ADDENDUM NO. 1

Additions & Renovations to Pleasant Run Elementary School
1800 North Franklin Road
Indianapolis, IN 46219

PROJECT: PLEASANT RUN ELEMENTARY SCHOOL RENOVATION & ADDITION

PROJECT NO: 2020061

1 WALL SECTION
A401 SCALE: 3/4" = 1'-0"

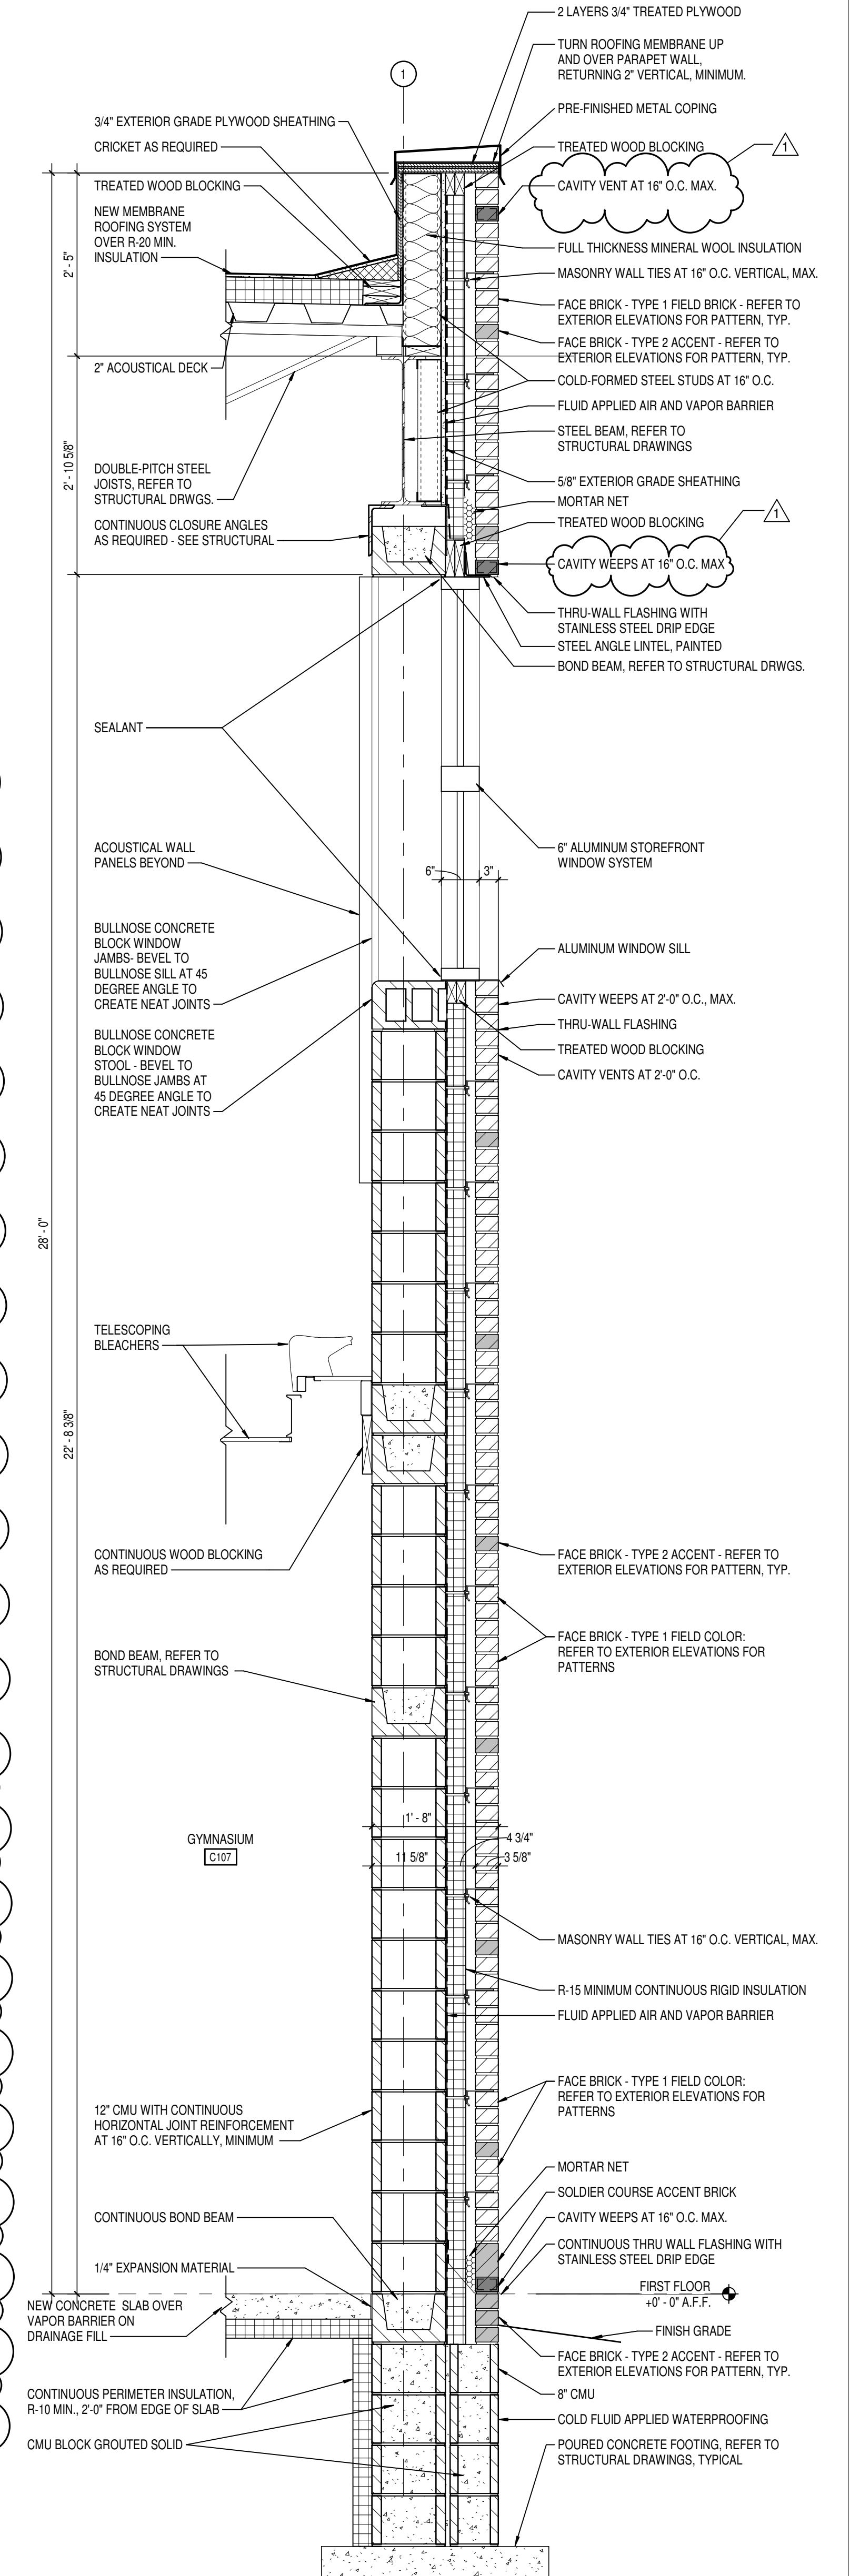
- A. At all WALL SECTIONS, replace any reference to Cavity Weeps and/or Vents to "16" O.C. MAX." in lieu of either note "24" O.C. MAX." or "2'-0" O.C. MAX.

DRAWING TITLE: EXISTING CONDITIONS AND DEMOLITION PLAN		
CERTIFIED BY:  		
DRAWING NUMBER C101		
PROJECT NUMBER 20200661 CRPE No. 200984-2020

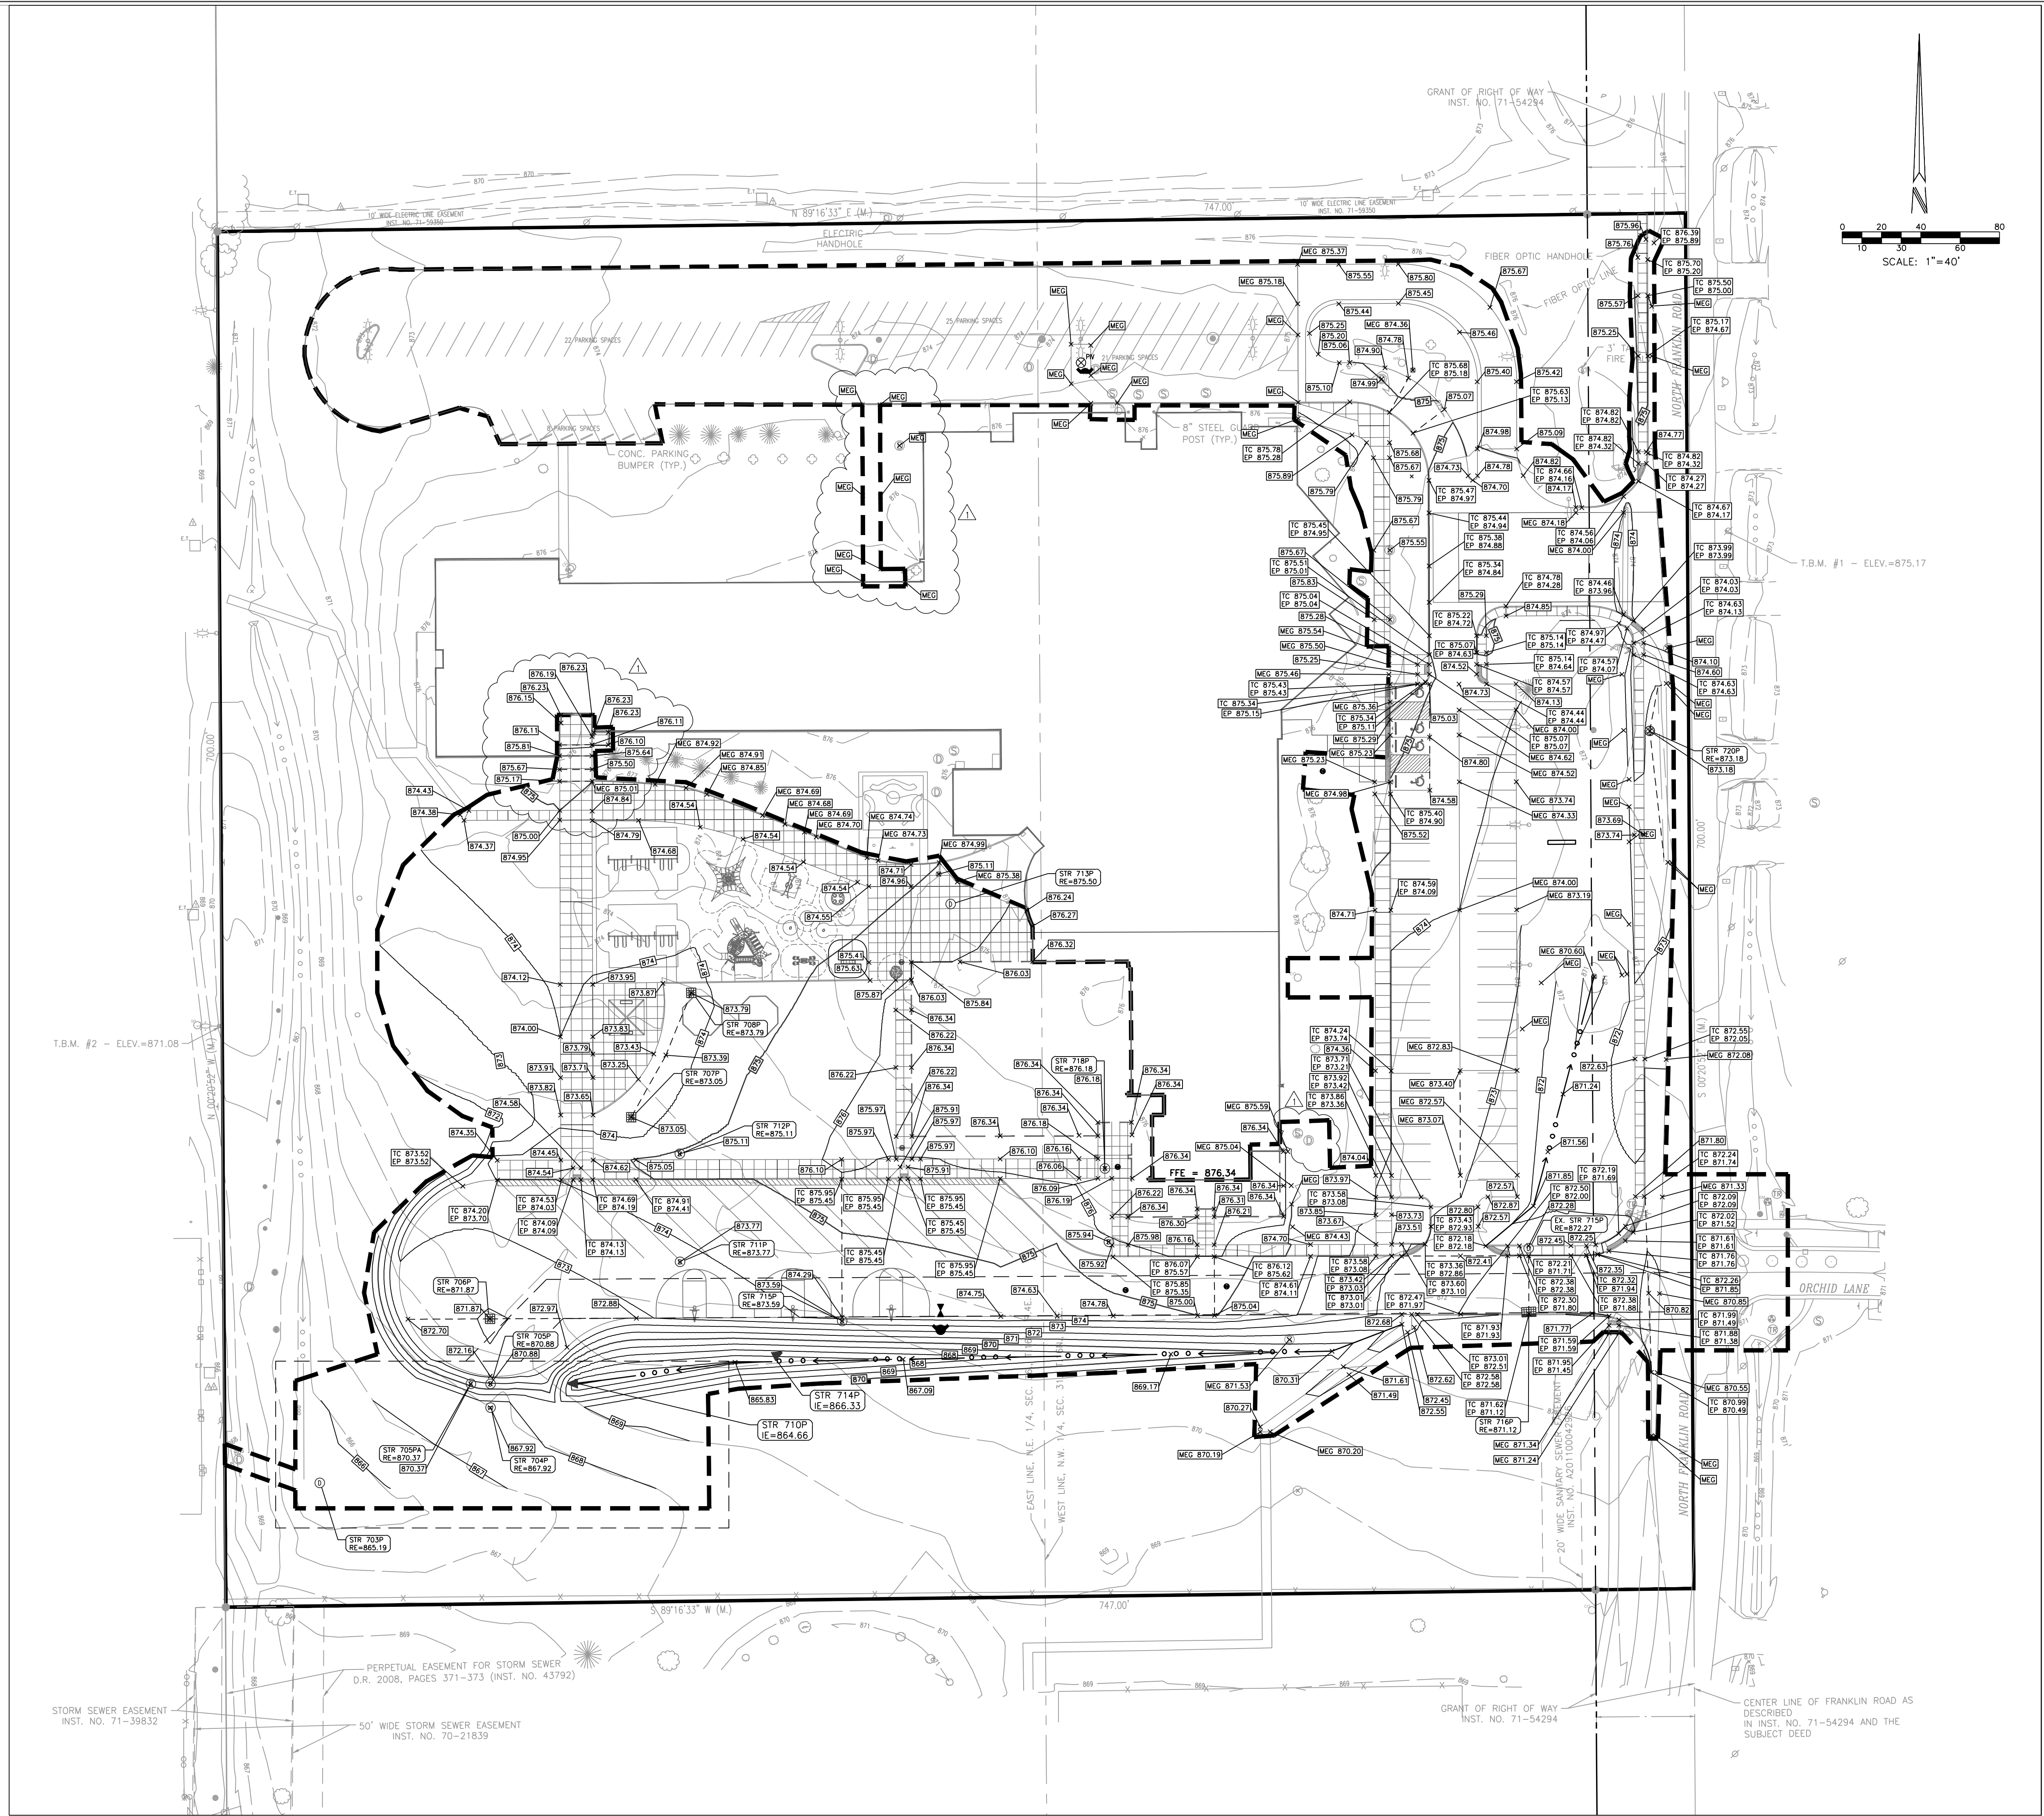
1. C101 Existing Conditions and Demolition Plan
 - a. The milling of the Parking lot on the north side of the building is replaced with sealcoat asphalt pavement, which is identified with keynote 49.

- b. Remove Concrete sidewalk on the north side of the building.
 - c. Revise the construction limits.
 - d. Add tree protection limits. A reference is made to the Tree Protection Plan.

- e. Revise pavement demo limits and milling limits around the loop drive that is northeast of the building.
 - f. Remove two trees near the southeast corner of the building.

DRAWING NUMBER
C301

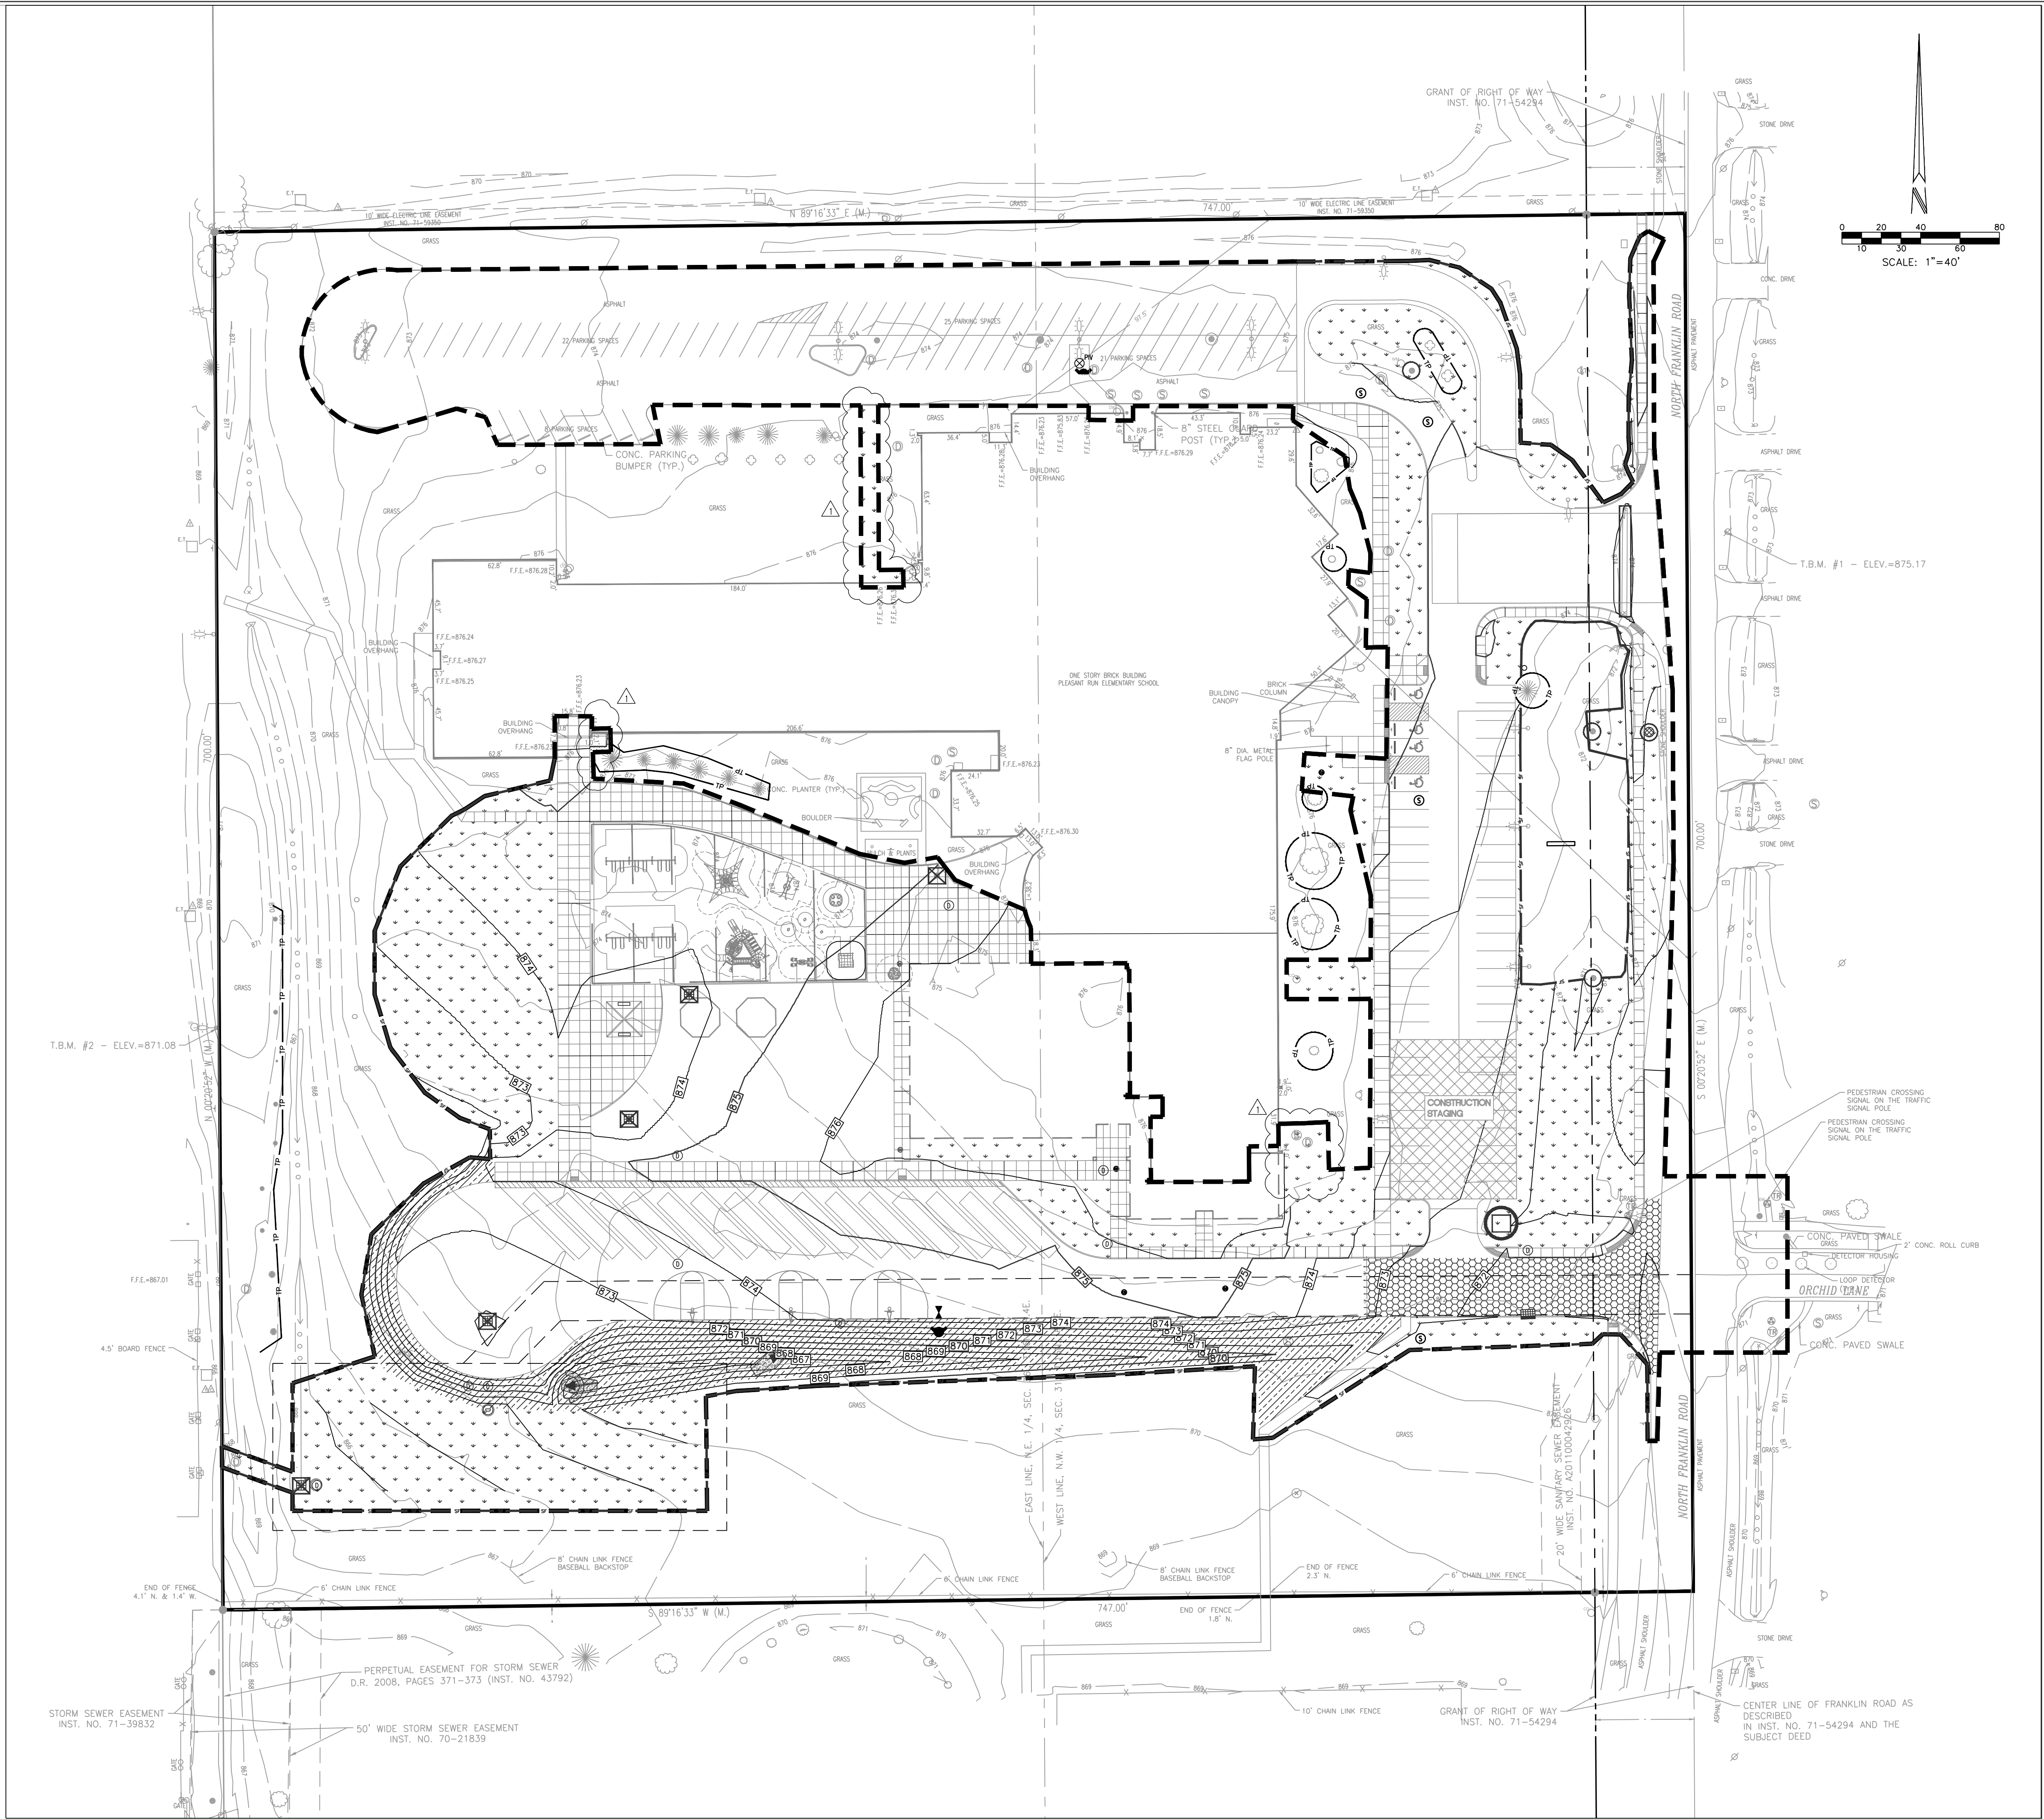
2. C301 Grading Plan
 - a. Revise grading for the updated sidewalk northwest of the playground.
 - b. Add match existing grade label (MEG) in the area where the sidewalk was removed north of the building.

- c. Revise construction limits.
3. C401 Stormwater Pollution Prevention Plan
 - a. Add seeding where the sidewalk was removed north of the building.
 - b. Add seeding near the updated sidewalk northwest of the playground.
